LOCAL HISTORIC DISTRICT: Dilworth

PROPERTY ADDRESS: 1908 Dilworth Road East

SUMMARY OF REQUEST: Addition

Charlotte Historic District Commission Case 2018-445
HISTORIC DISTRICT: DILWORTH
ADDITION

1 PROPOSED FRONT ELEVATION
1/4" = 1'-0"

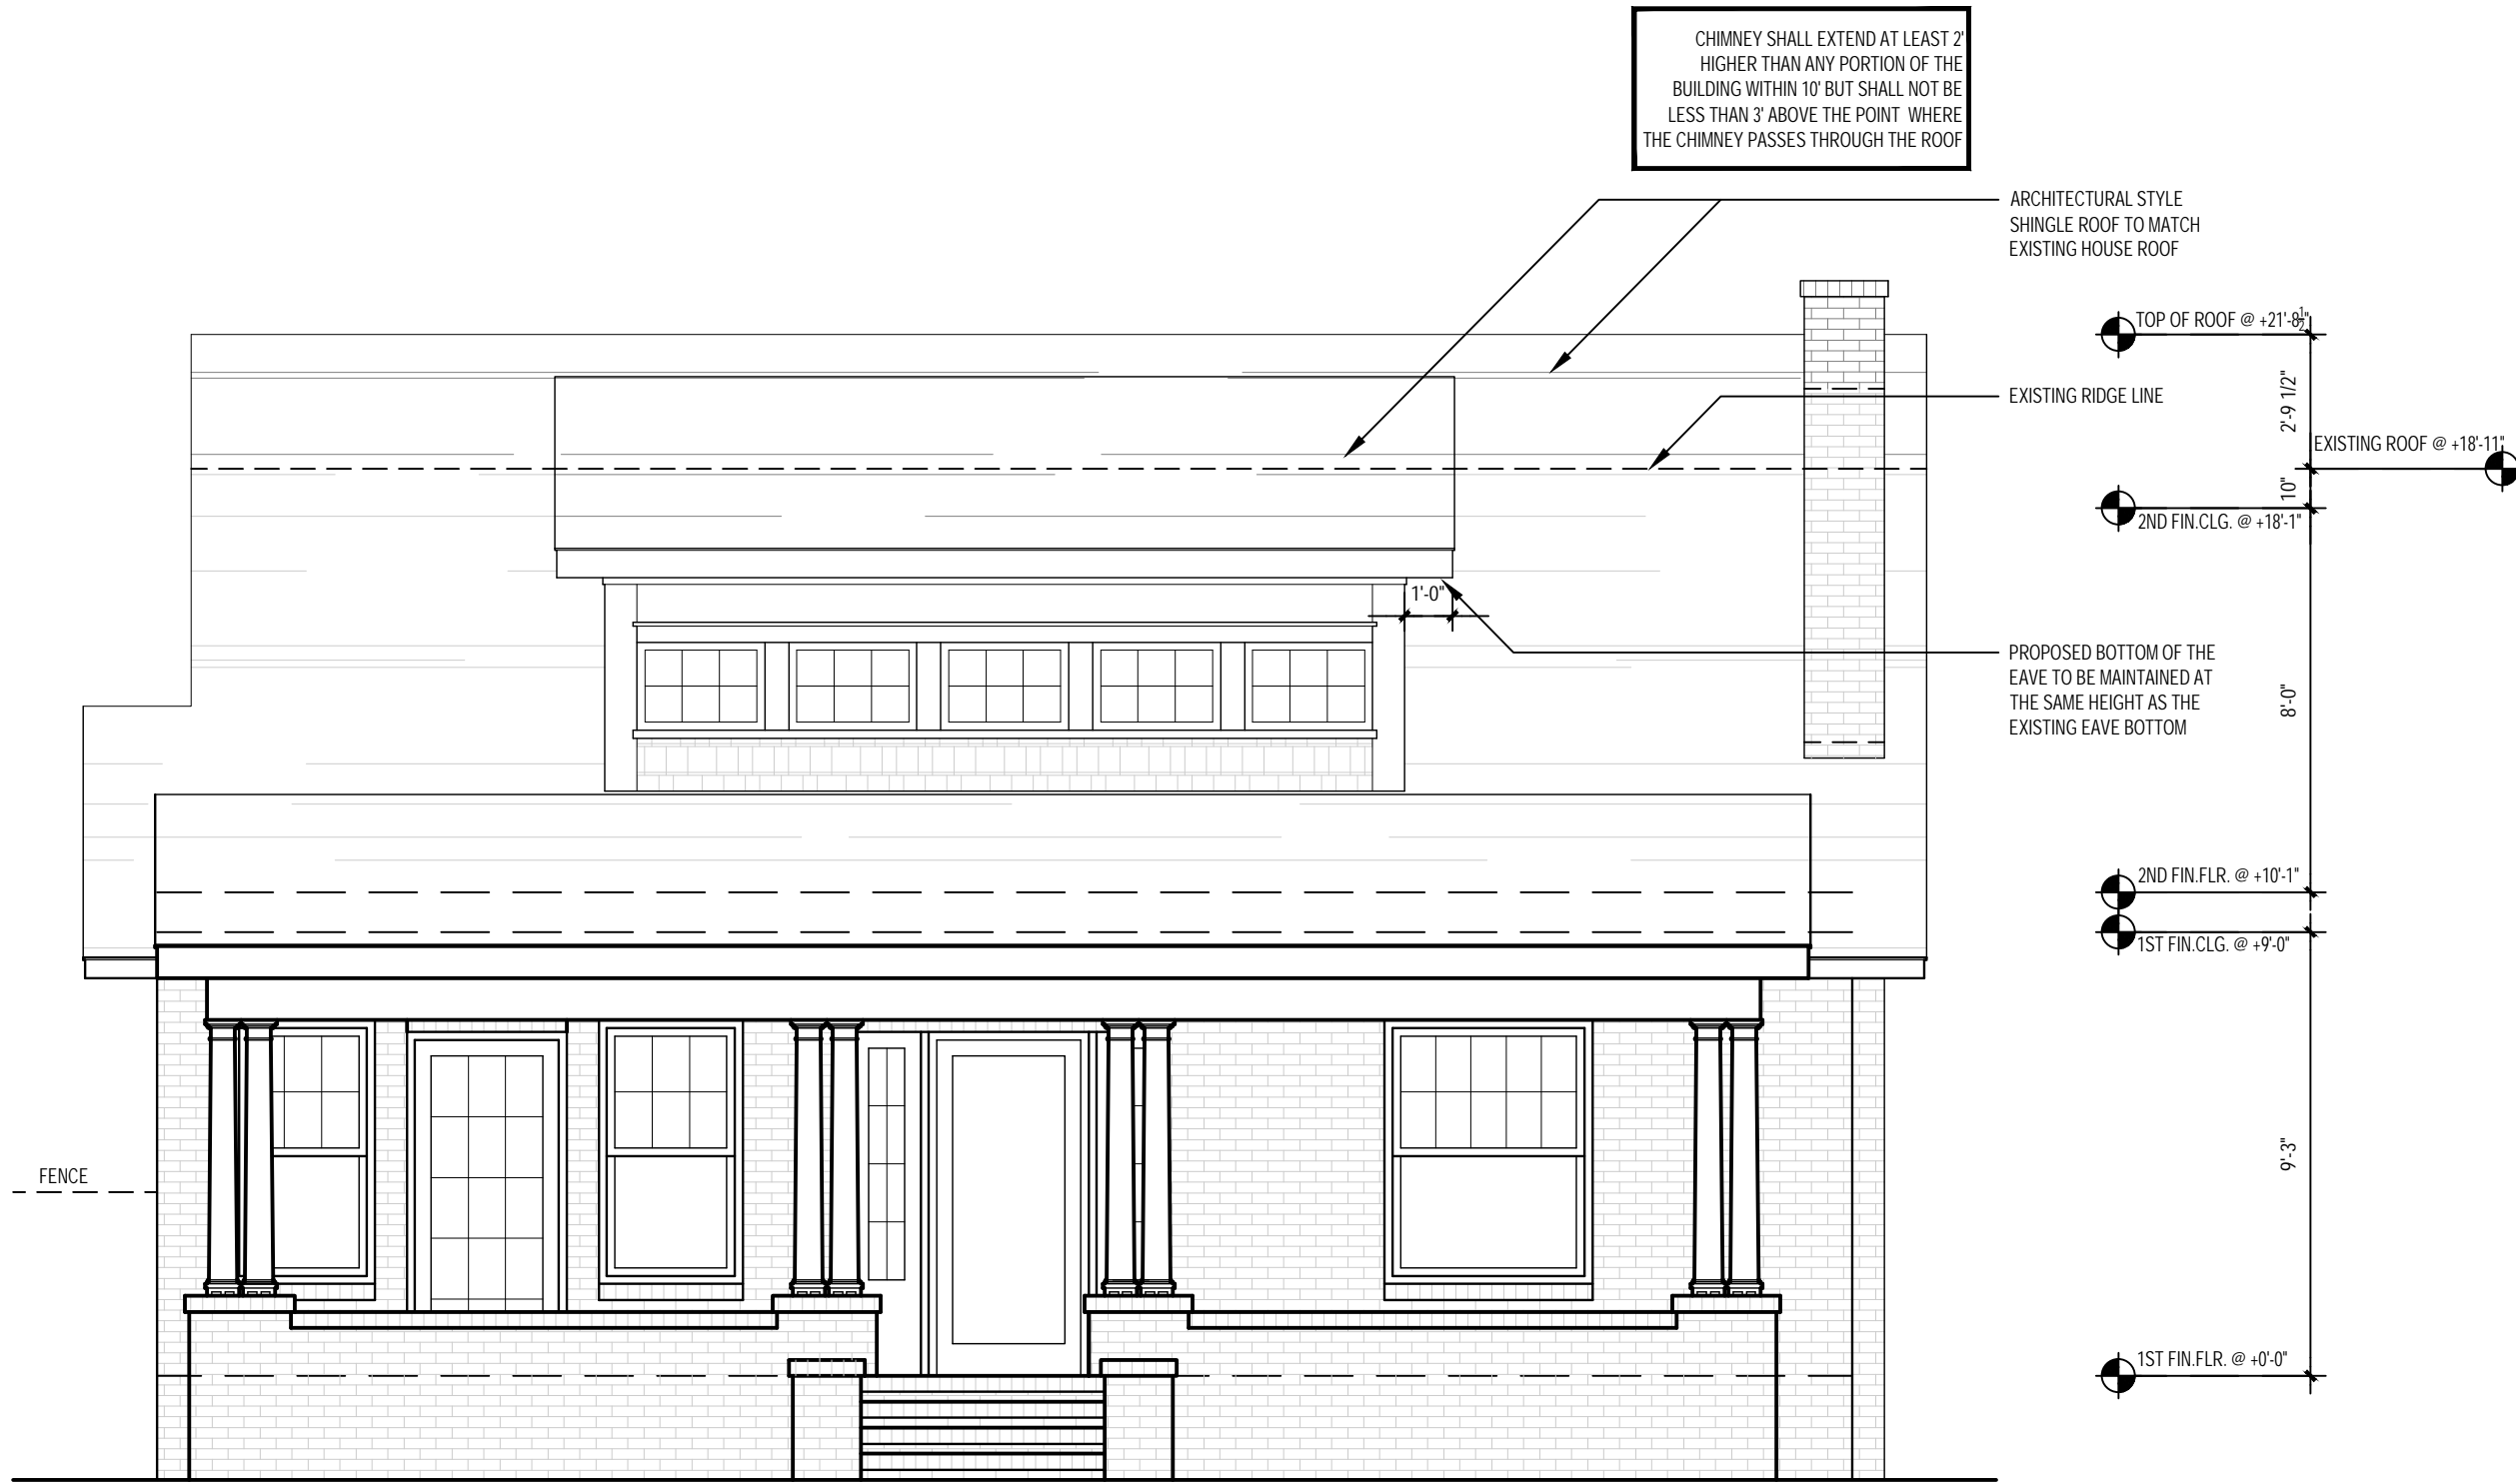
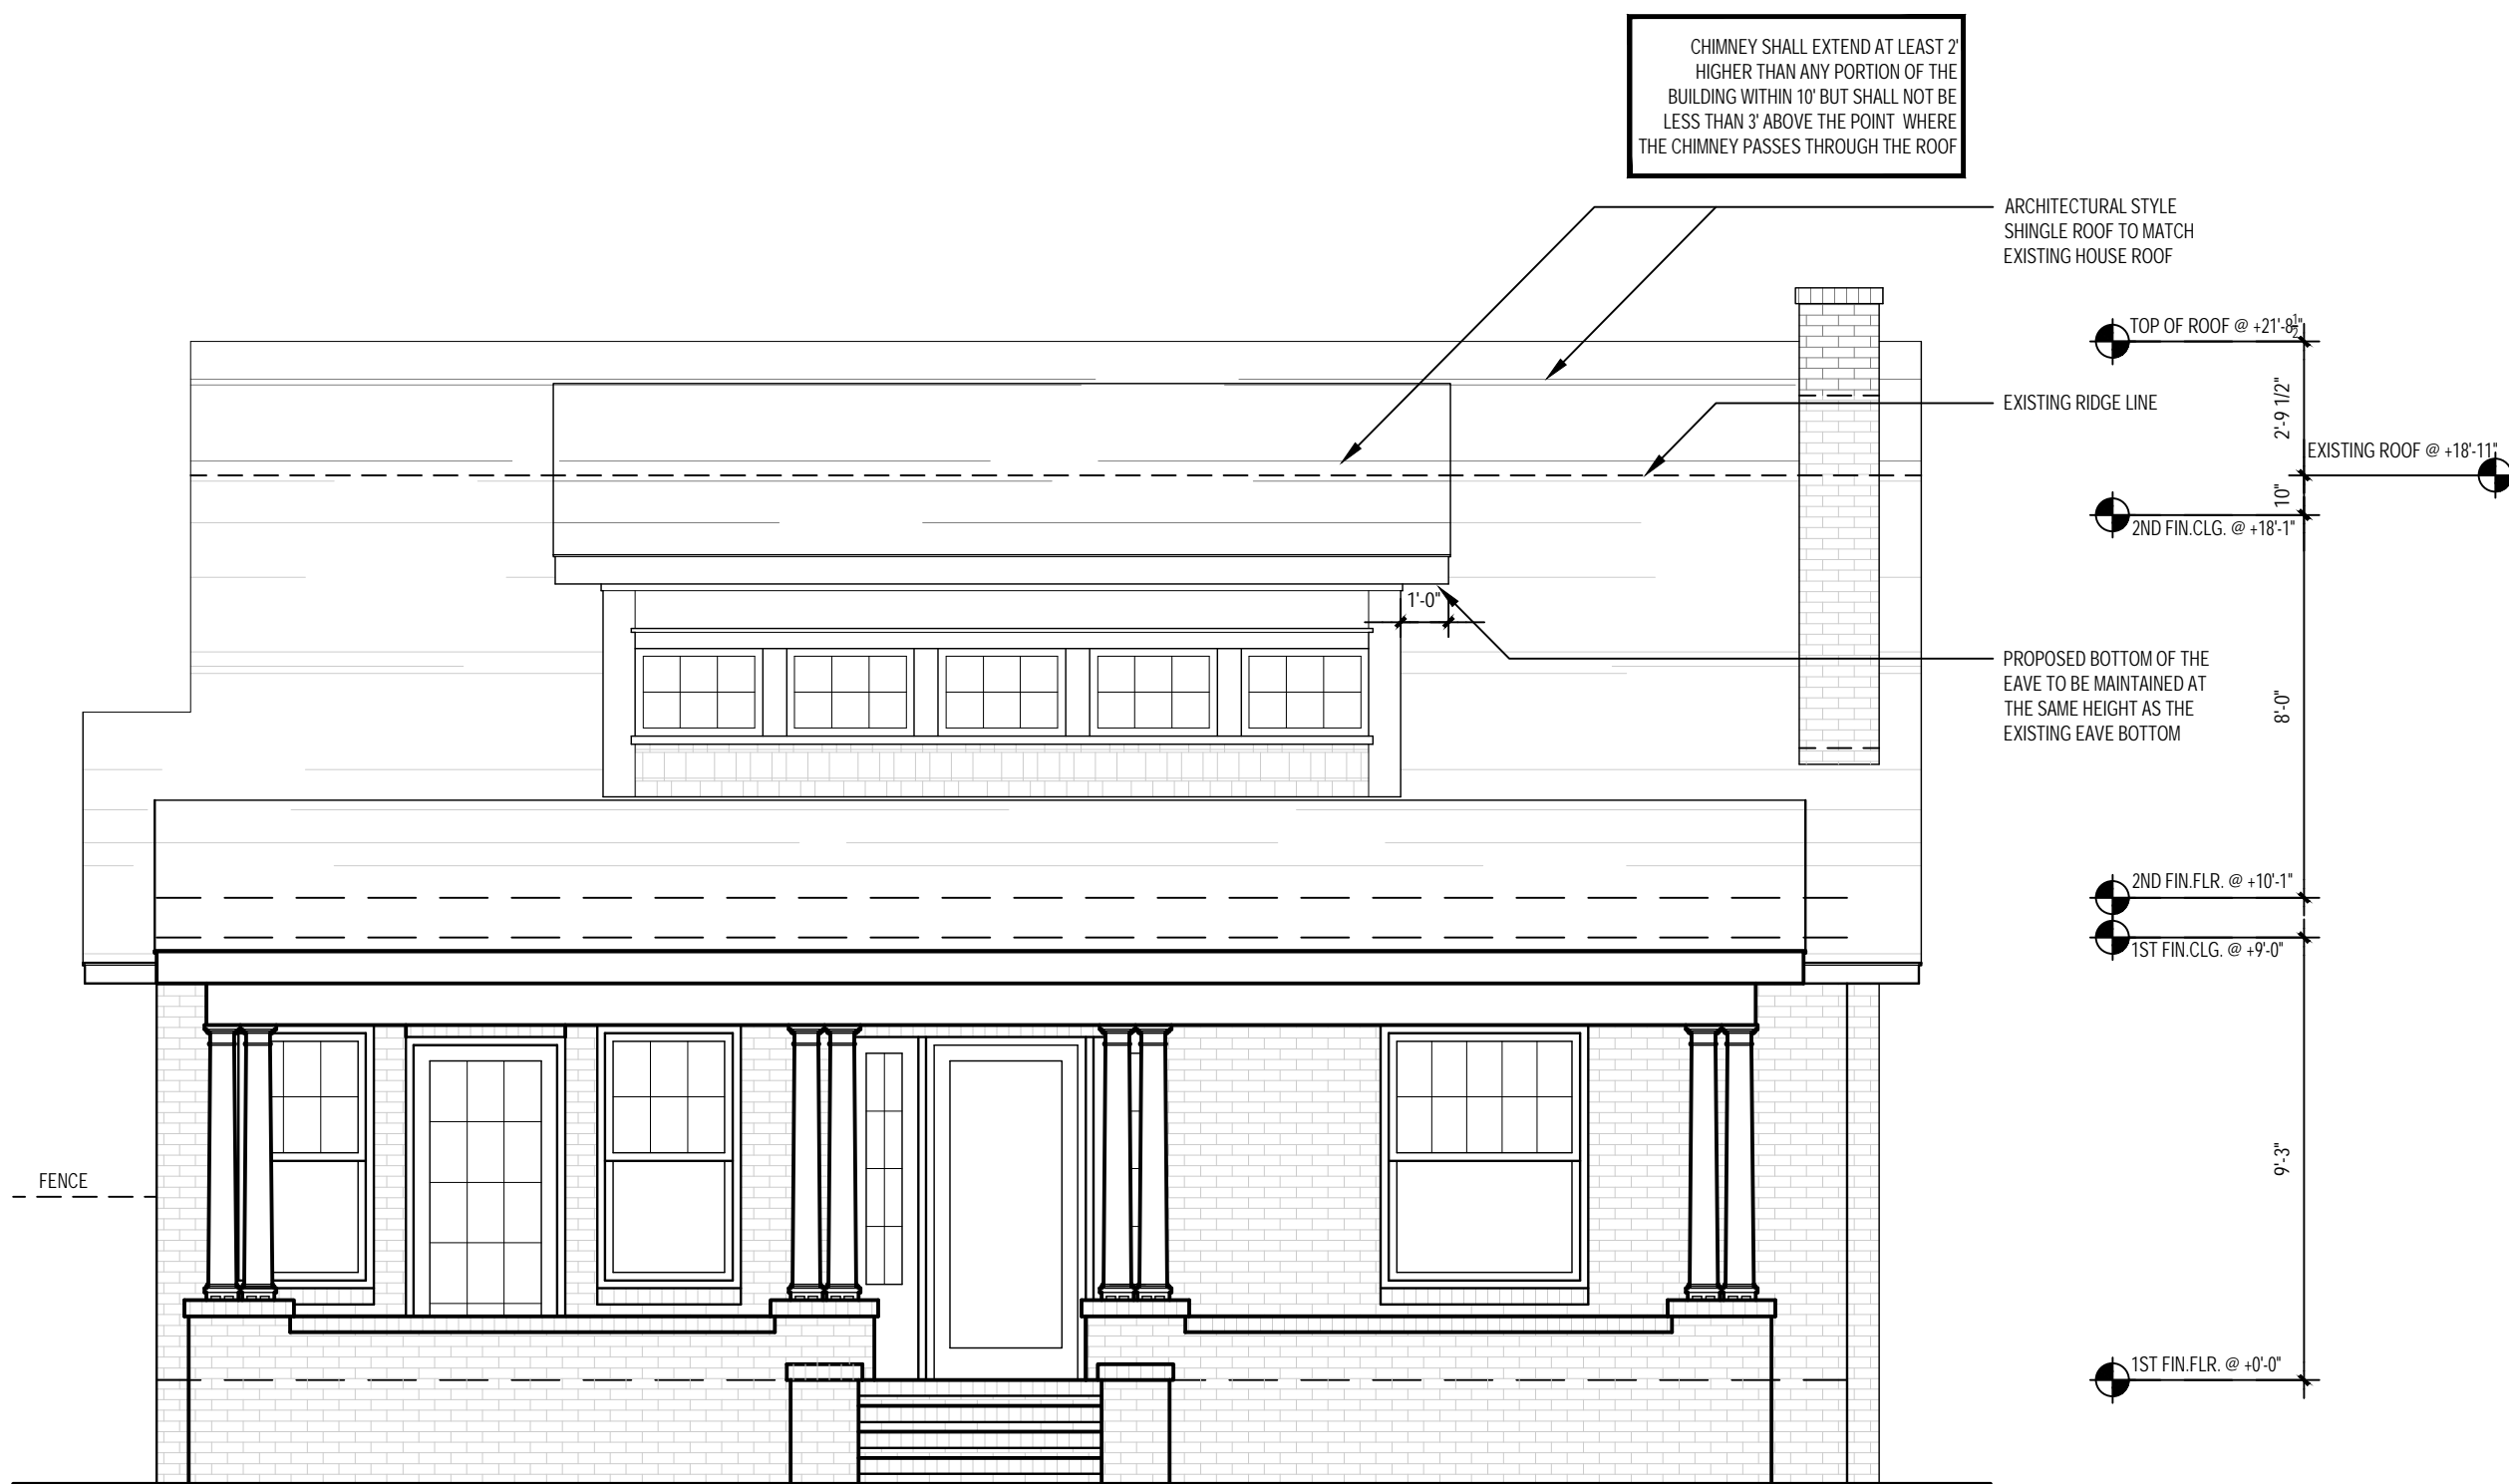
1. Additions, 7.2, item 3, maintain the original gable ends.
2. Re-study fenestration on side gables on the second story.
